Access Compliance Report Public Rights-of-Way (Curb Ramps)

Main Street: N/A Cross Street: O_NEILL_DR Location: SW

ADA ID: RPRK211118120217 Ramp Type: Type 1 - Perpendicular Diagonal Initial Pass/Fail: Pass Overall Compliance: No Severity Score: 19

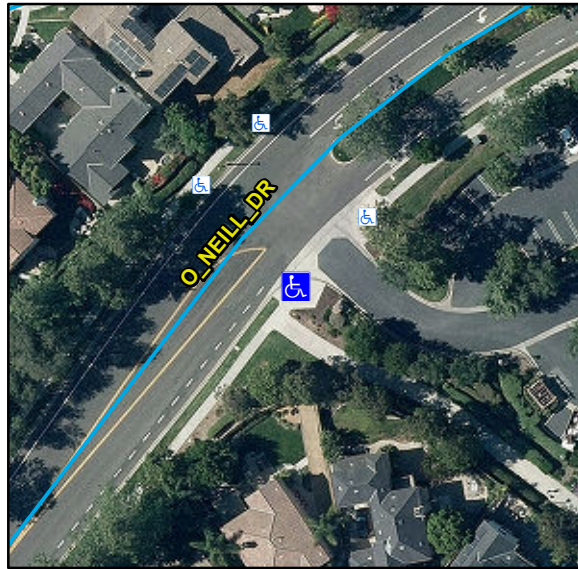
N/A	Ramp Inside Crosswalk 1	N/A	Yes	Ramp Inside Crosswalk 2	N/A
	Crossing 1 Slope (%)	4		Crossing 2 Slope (%)	2.1
	Crossing 1 Cross Slope (%)	3.7		Crossing 2 Cross Slope (%)	3
Yes	Gutter Ponding	No	Yes	Curb Slope	4.1
Yes	Gutter Lip Height (in)	0		Road Run Slope (%)	5.5
No	Gutter Run Slope (%)	6		Road Cross Slope (%)	5.3
Yes	Gutter Cross Slope (%)	4.8			
Yes	Overall Surface Condition: Acceptable		Yes	Perp Joint Present	Yes
	Cross Gutter Present?	Yes		Spandrel Present?	Yes
	Replace Cross Gutter?	No		Replace Spandrel?	No

Remove & Replace Curb Ramp With Two New Directional Ramps or Equivalent. Remove & Replace Gutter.
